TOWN OF NISKAYUNA
Planning Board and Zoning Commission
Agenda
May 9, 2022
7:00 PM

ITEM TITLE: DISCUSSION: 2341 Nott St. – ShopRite Plaza – site plan app. for placing a Chase Bank ATM machine in the plaza parking lot

ITEM TITLE: DISCUSSION: 2303 Nott St. E – Starbucks – Application for Site Plan Review for interior and exterior renovations to the shop.

EXISTING CONDITIONS & SITE PLAN

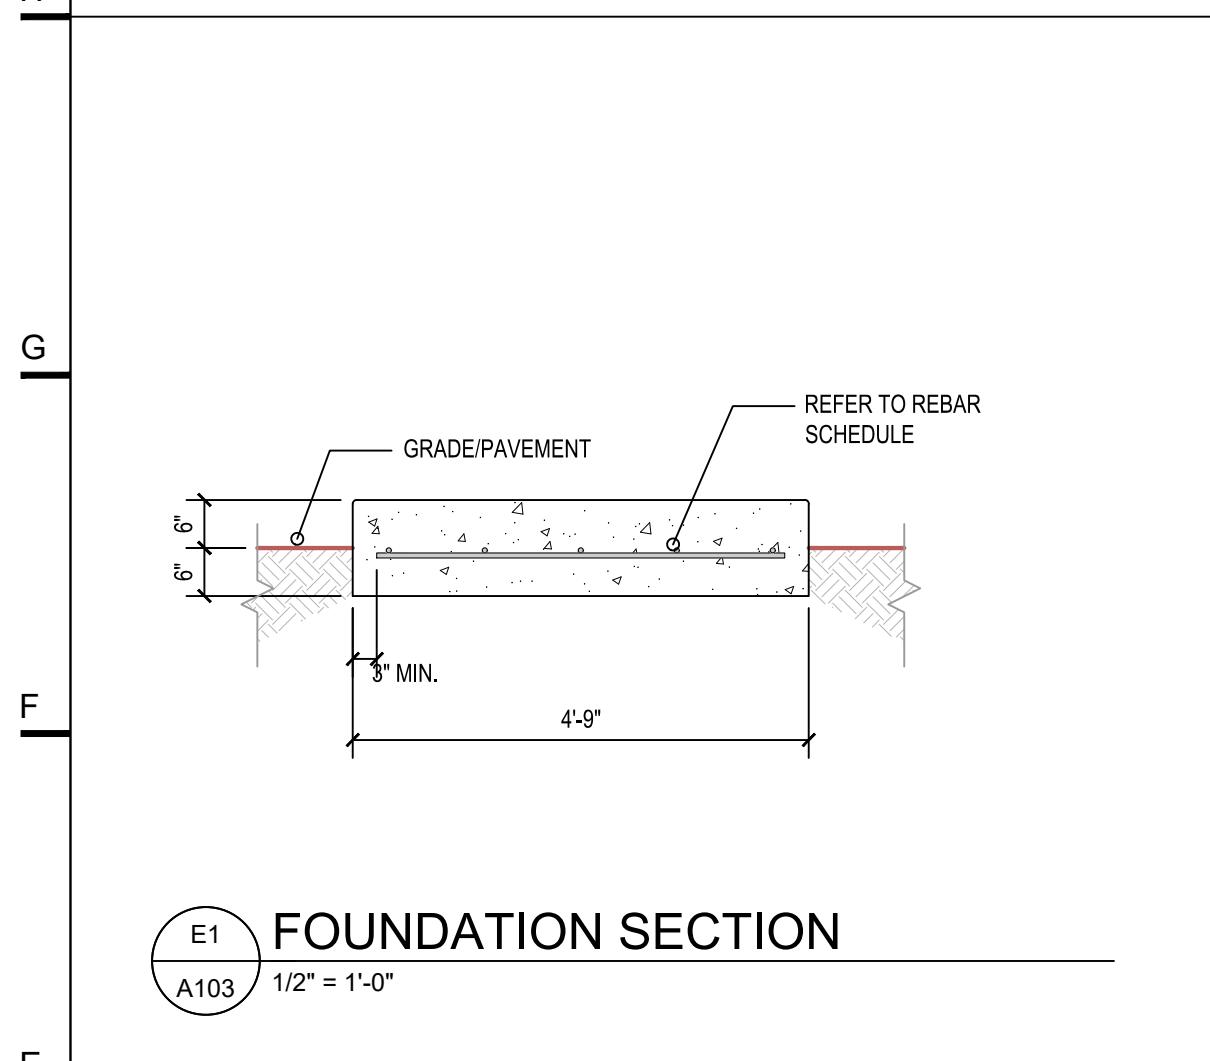
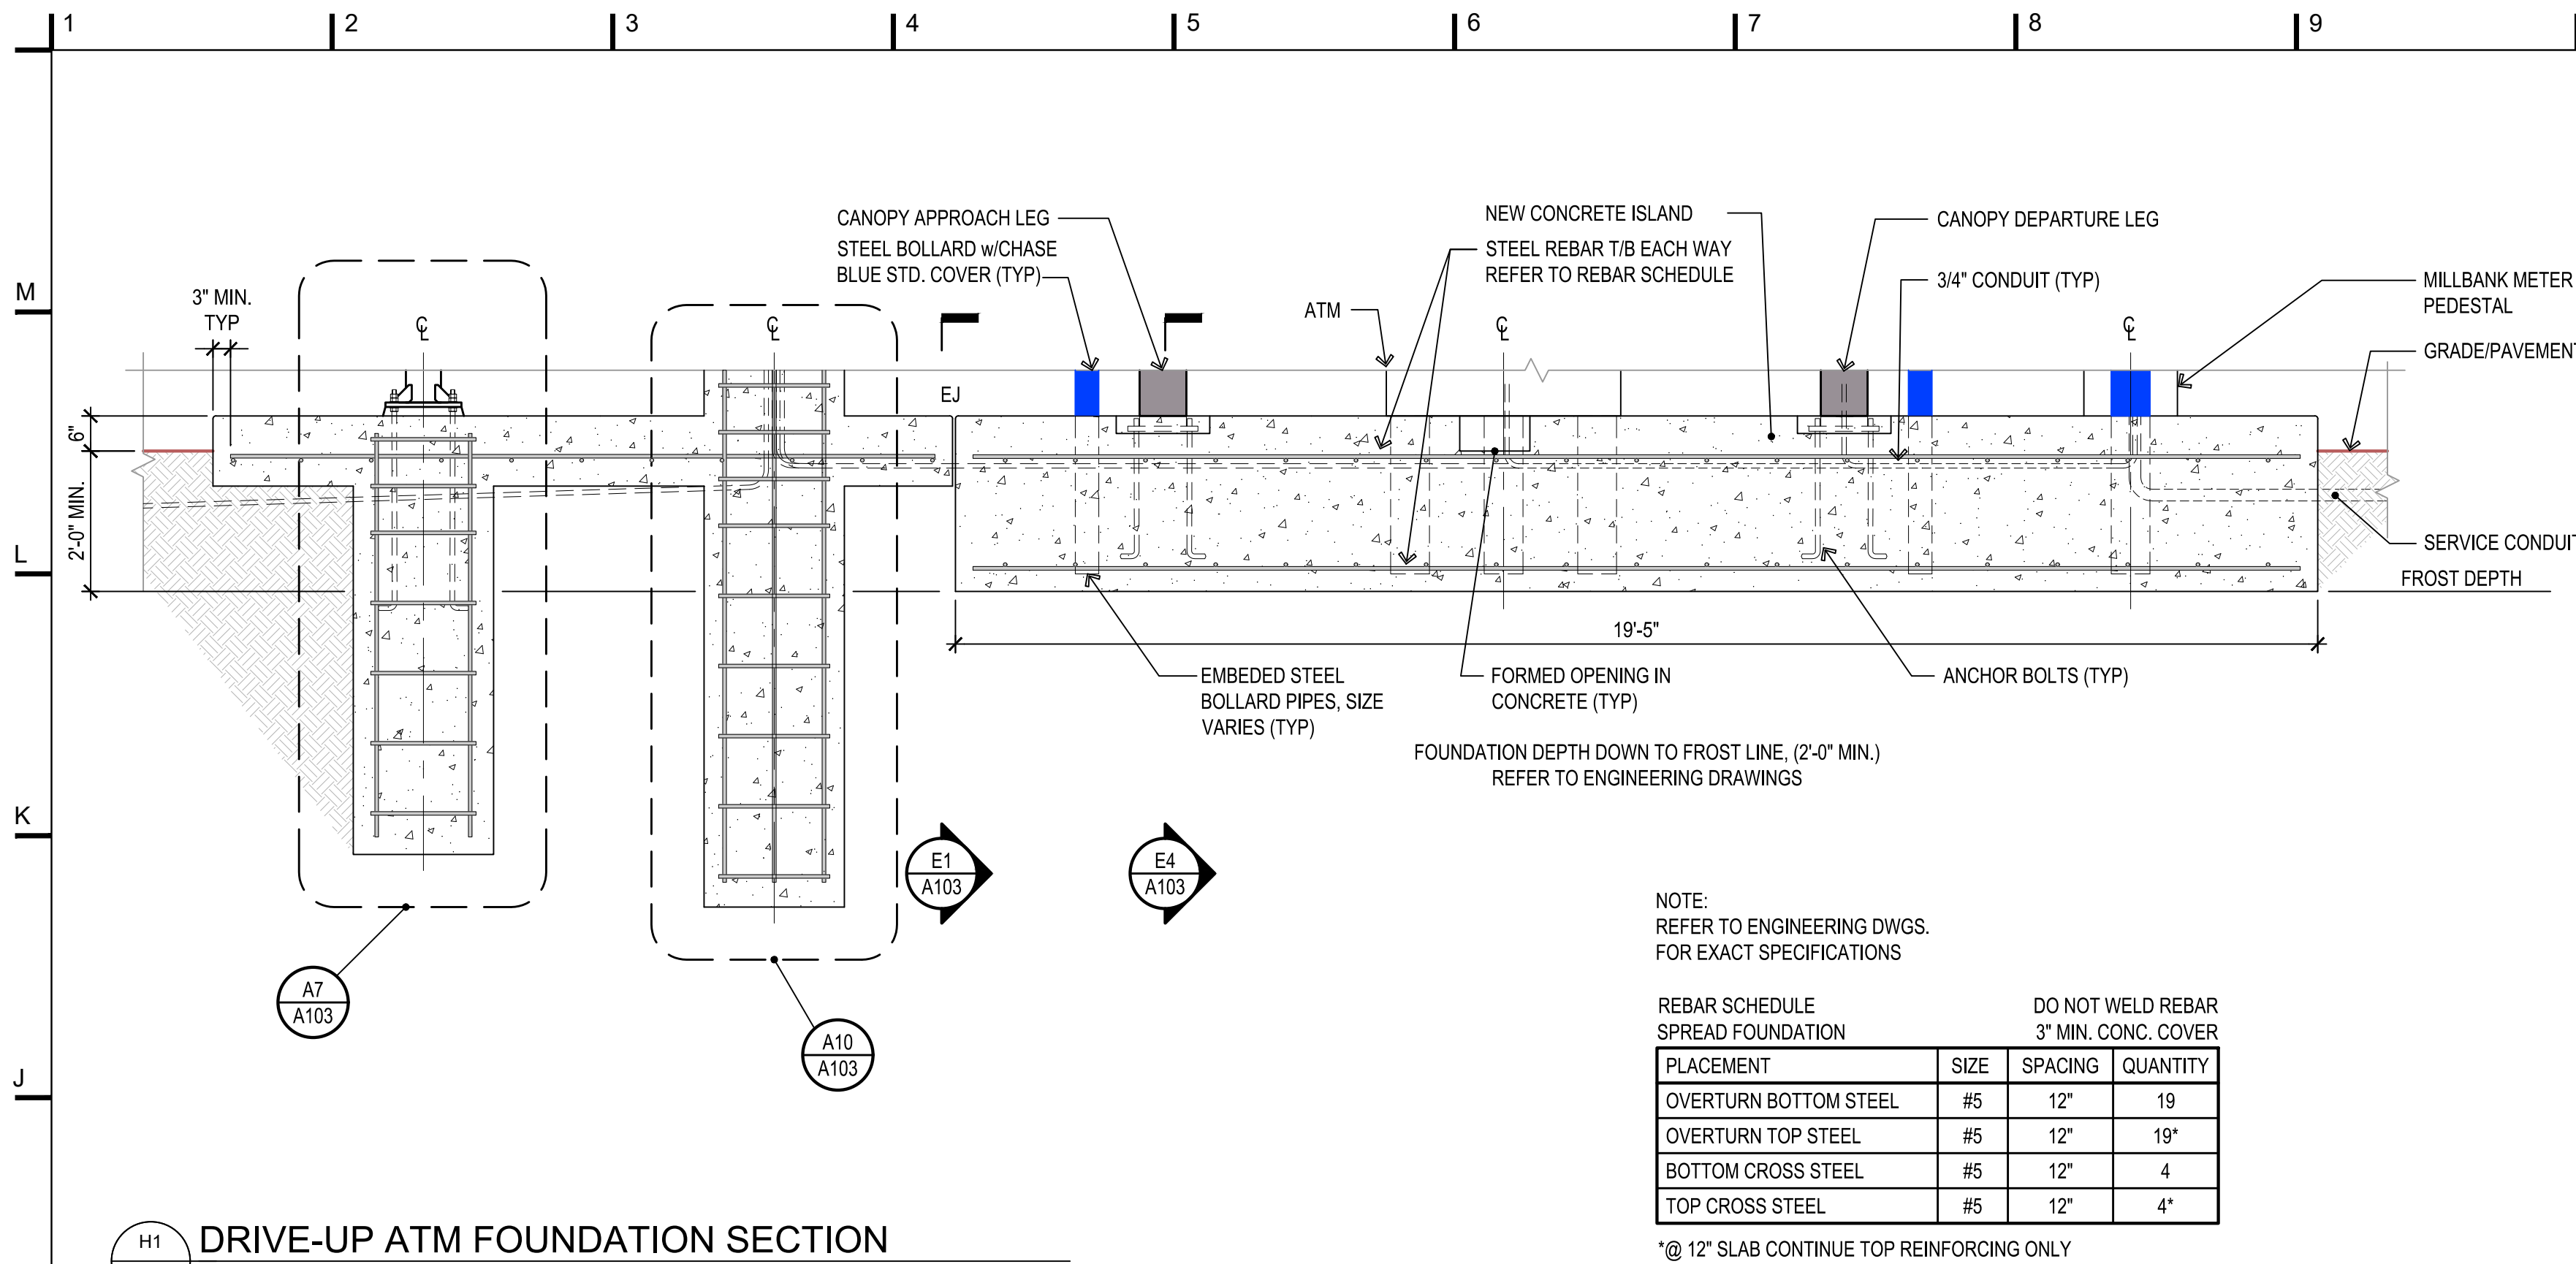
As proposed, page A102 of the drawing set includes a light pole with an area light measuring 23' high (3' high concrete base + 20' high light pole) located at the entrance to the ATM machine. Therefore, a waiver of 1' (23 – 22) of pole height from finished grade is required.

As proposed, page A105 of the drawing set includes a photometric plan of the project area. The area immediately around the ATM is illuminated to approximately 5 fc. The illumination at a 25' radius from the project site is illuminated to approximately 2 fc. The illumination level at a radius of 50' from the project site is typically significantly less than 1 fc and equivalent to the larger parking lot area.

Pages A102, A103 and A104 of the aforementioned drawing set include design details for the proposed ATM. Several portions of the ATM station infrastructure and associated graphical displays should be reviewed by the Board relative to the requirements set forth in Section 220-4 of the zoning code. The drawings include a "non-illuminated signage option" that reads "CHASE" followed by the Chase Bank logo on one of the canopy legs.

1 SITE PLAN
Scale: 1/16" = 1'-0"

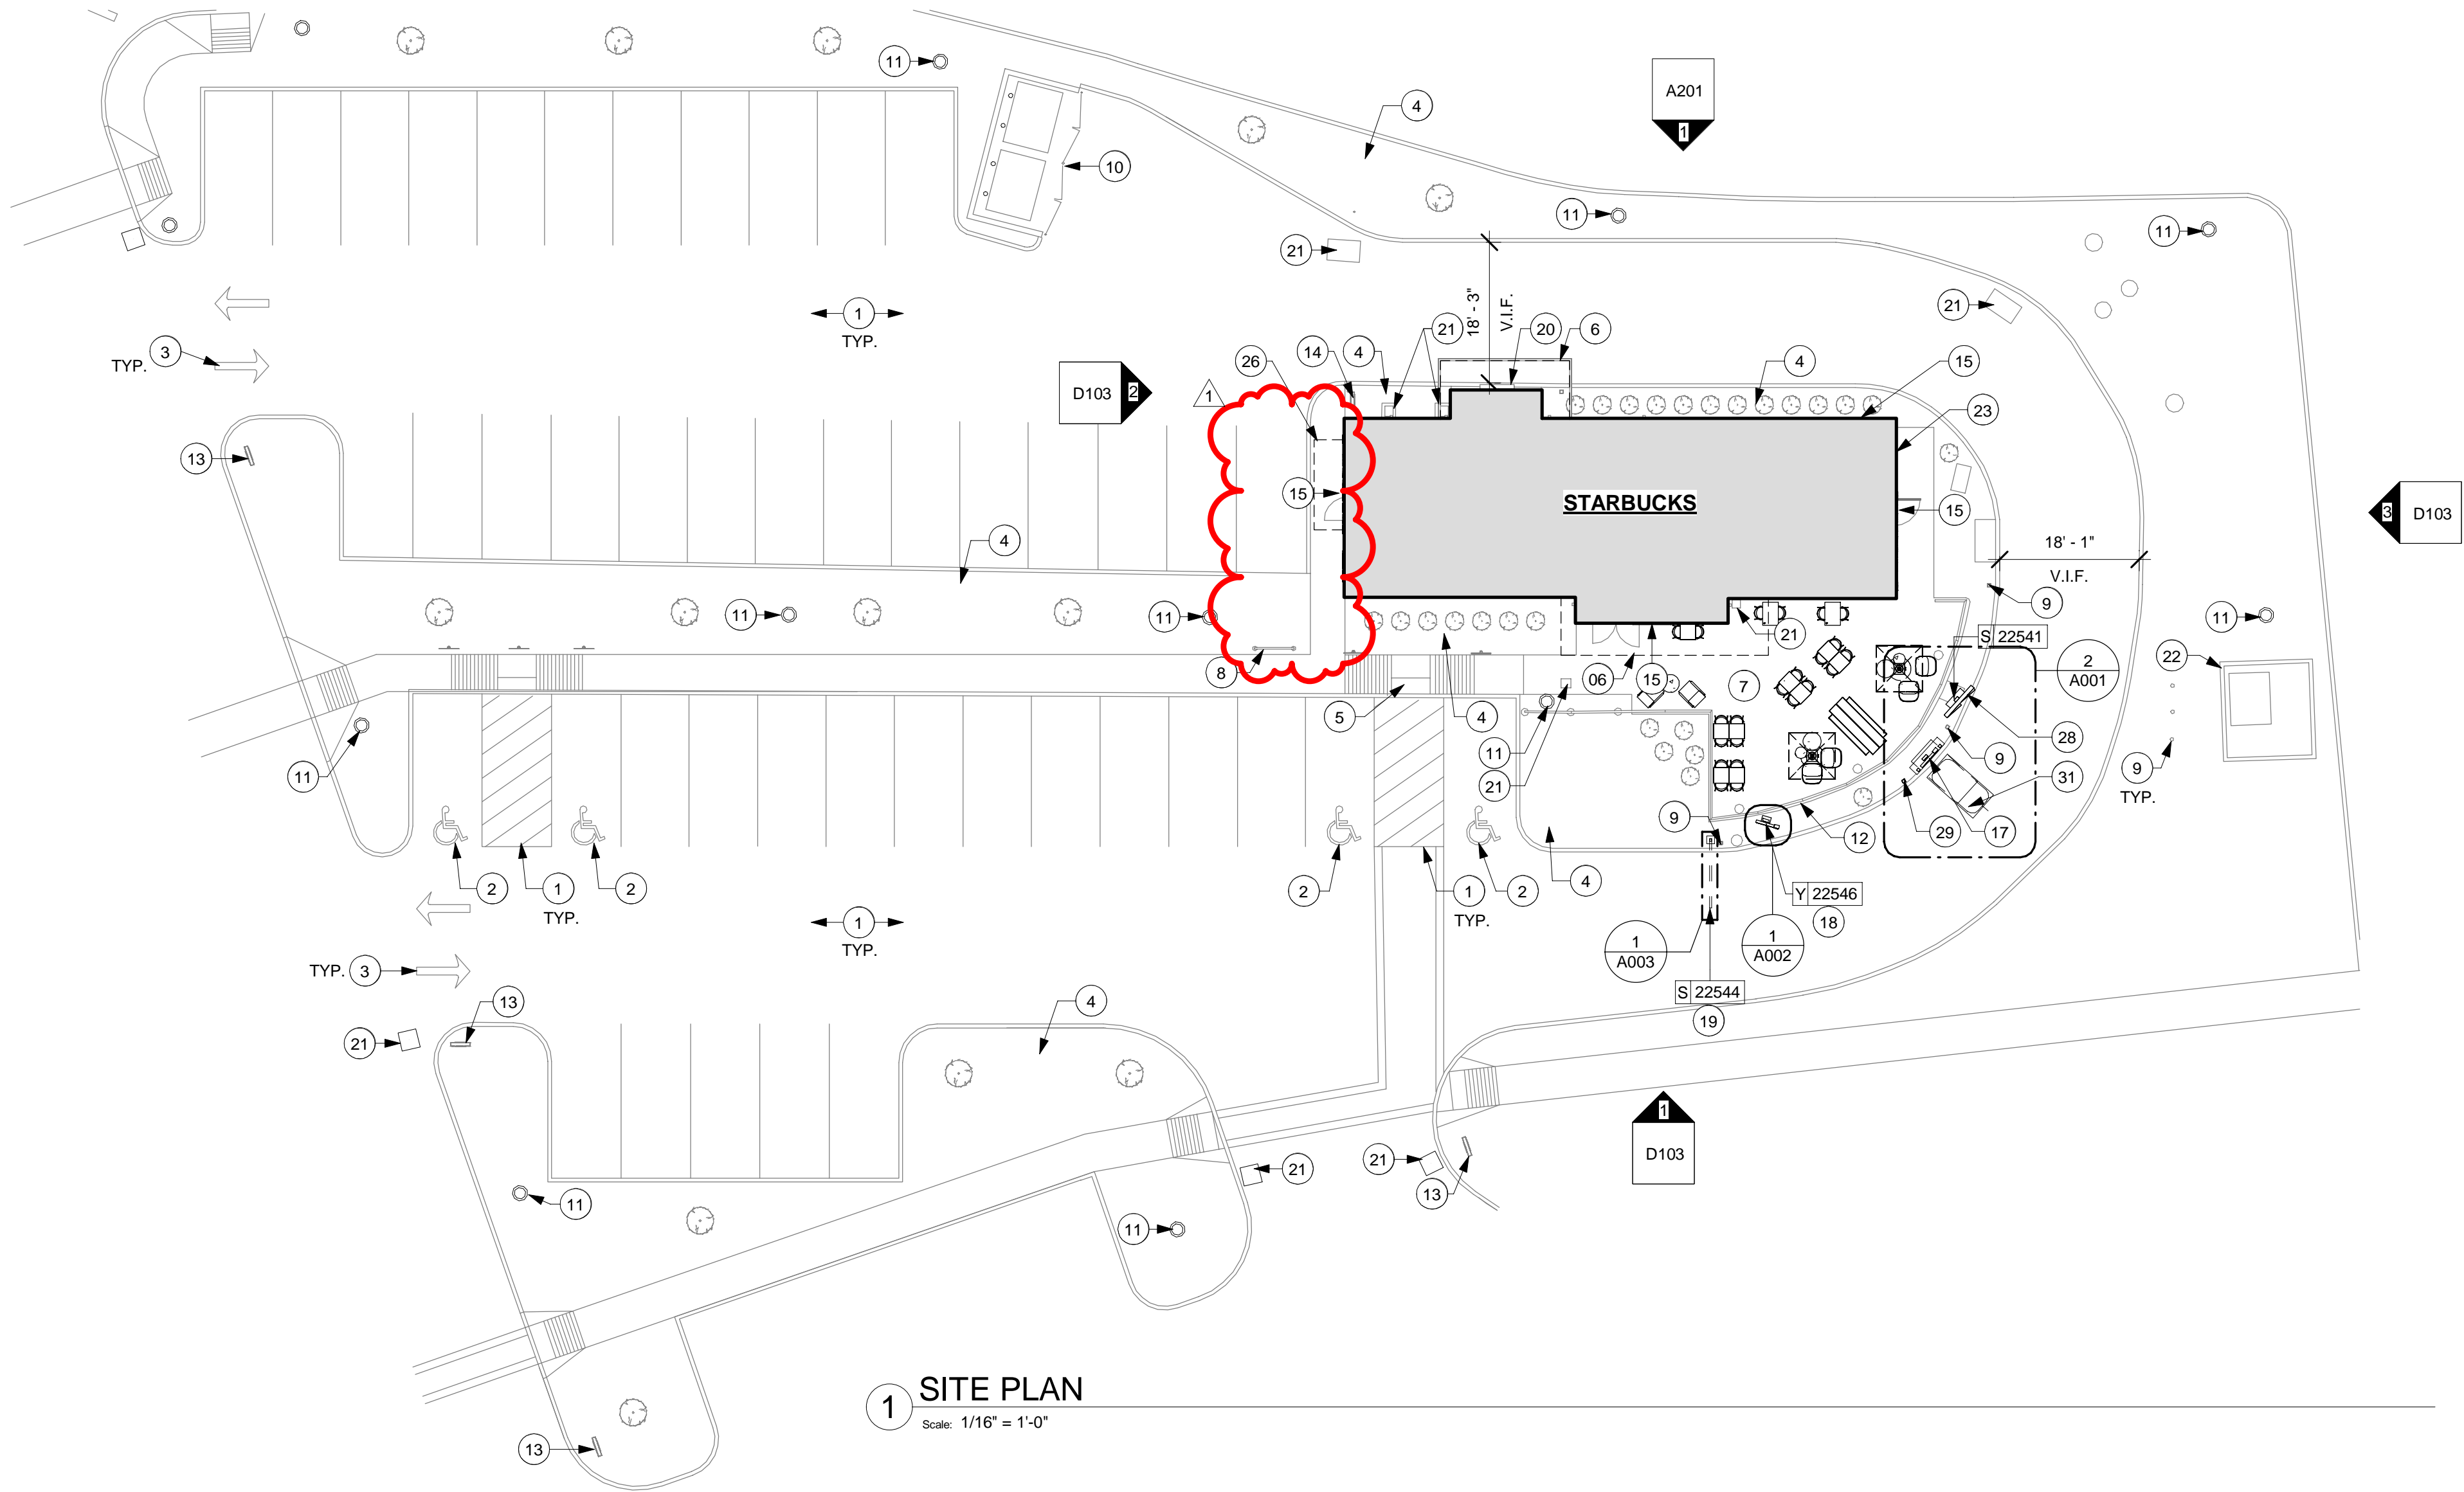
--- Items identified as F, G, H, I, J, K, L are proposed to be added to the project site

SITE PLAN: DEMO

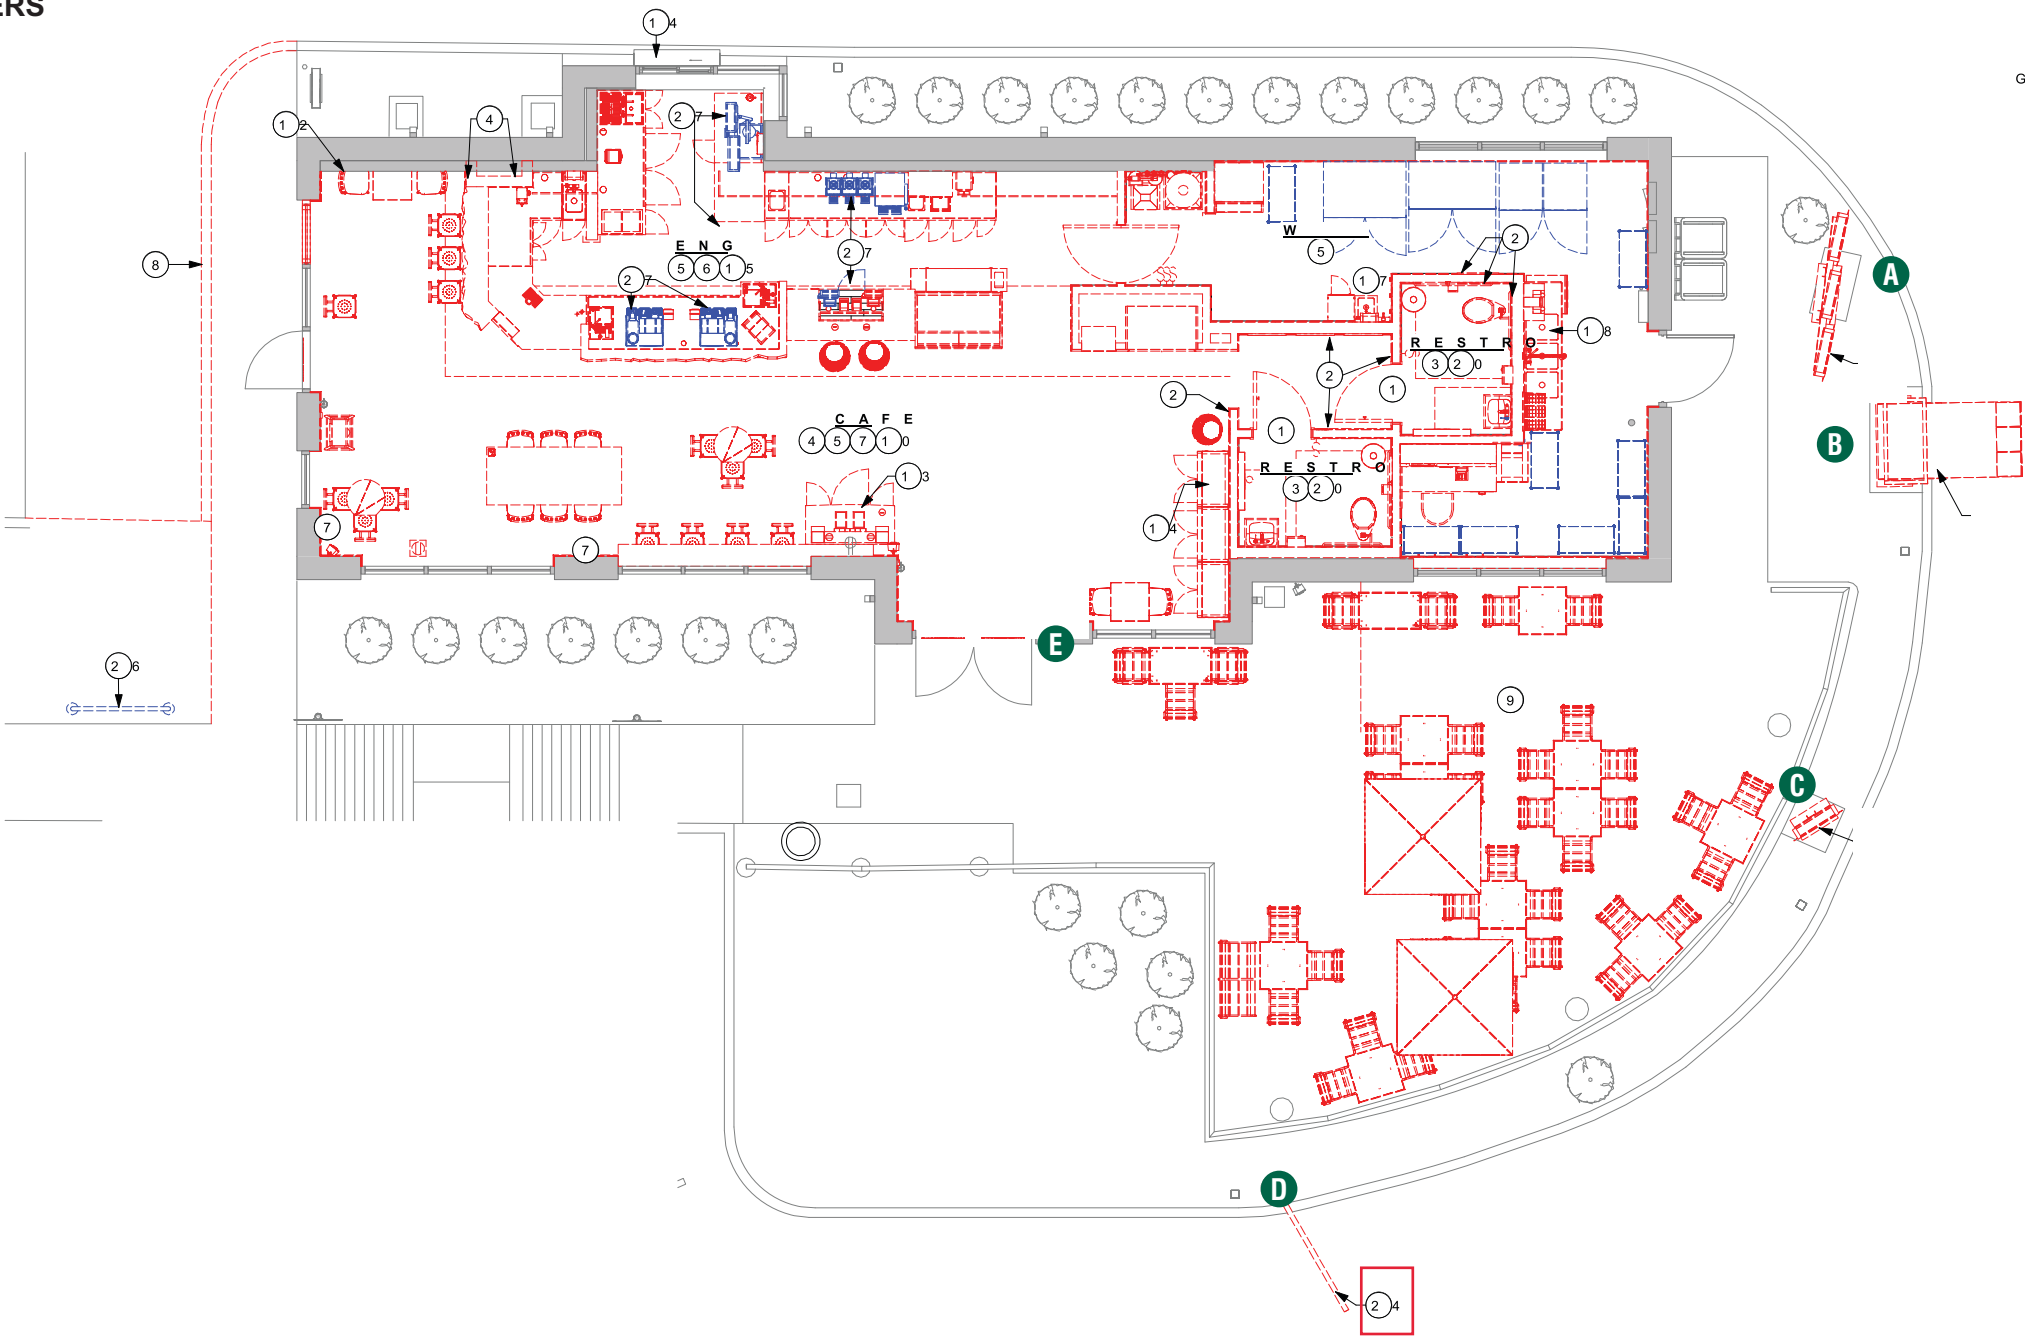
1. Site Plan: Demo
